4550511 STRUCTURES FOUNDATIONS  
COMMENTS FROM INTERNAL/INDUSTRY REVIEW

Comments: (11-1-21, Internal)

**455-15.8.4 Fluid in Excavation At Time Of Concrete Placement: (Both 4550511 & SP4550000DB Specs)**

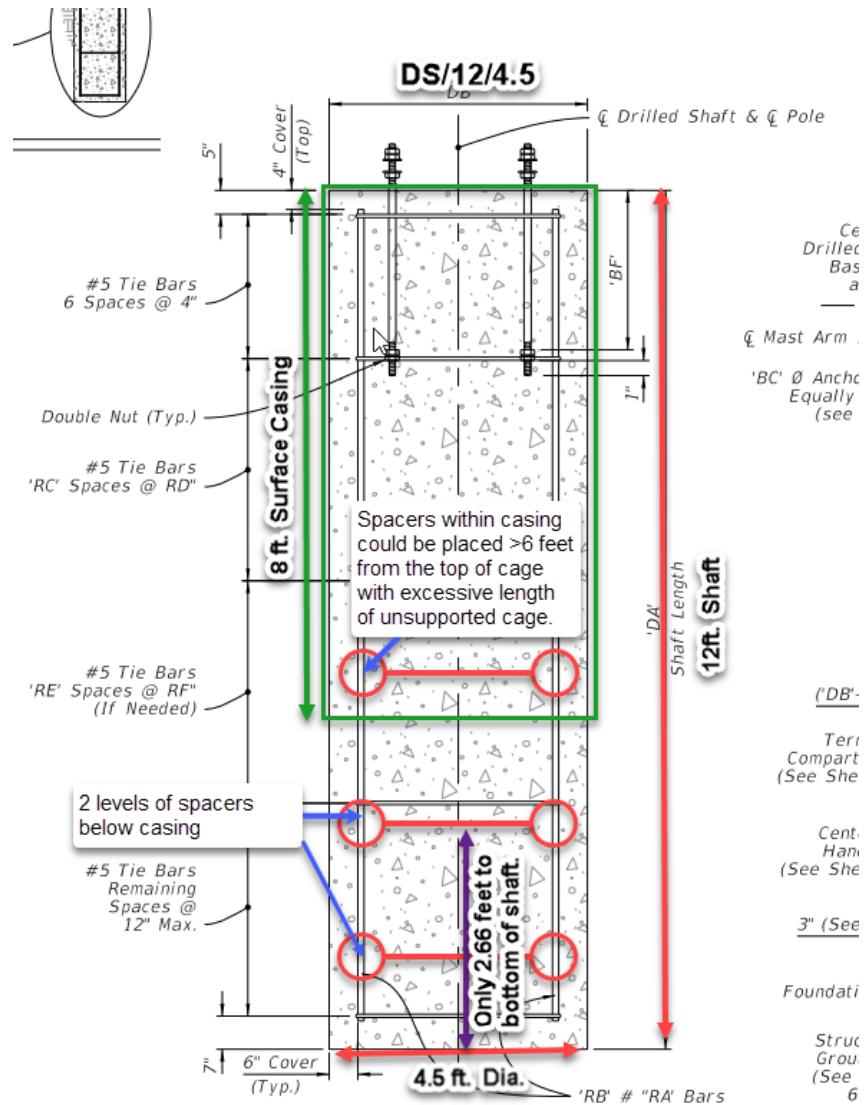
6. The additional table for Mixed Polymer Slurry Properties located within this section, seems to be contradictive to the table in shown in 455-15.8.3 concerning the ranges of viscosities on the miscellaneous structure foundations and the specification language.

- a. It has been accepted to date that this paragraph is dealing with the testing of polymer slurry, “... *in the shaft prior to placing the concrete,*” 455-15.8.4. Moreover, the polymer testing requirement of this specification is documented on the construction form 700-010-84 on the Fluid-Slurry sheet under section b) titled, “*Before placing concrete.*” Within these premises, the first paragraph of the specification states, “*When any fluid is present in any drilled shaft excavation, including shafts to support sign, signal, lighting and ITS structures, the applicable test methods and reporting requirements described in 455-15.8.1, 455-15.8.2 and 455-15.8.3 apply to tests of fluid in the shaft prior to placing the concrete.*” The last portion of this specification sentence directs the user to apply

the testing ranges listed in section 455-15.8.3. Following this direction back to the last section, the polymer slurry is shown to have a viscosity range of 50 seconds to upper limit recommended by the manufacturer for miscellaneous structure foundations. Whereas, below the opening paragraph in the 455-15.8.4, the user is directed with the following language, “*When polymer slurries are used ensure the properties of the polymer slurry are within the following acceptable ranges at the time of concrete placement.*” The following range for polymer slurry is now listed as 50 seconds to the upper limit defined by APL, which is assumed to apply to all shaft types and is now contradictory to the table in 455-15.8.3: concerning polymer viscosity for miscellaneous structure foundations. **This contradictory question caused the formation of the question below.**

7. Is there a difference in the interpretation of the language of polymer testing in a shaft, “At time of concrete placement,” verses, “prior to placing the concrete,” concerning the utilization of the additional table for polymer slurry testing properties in 455-15.8.4?
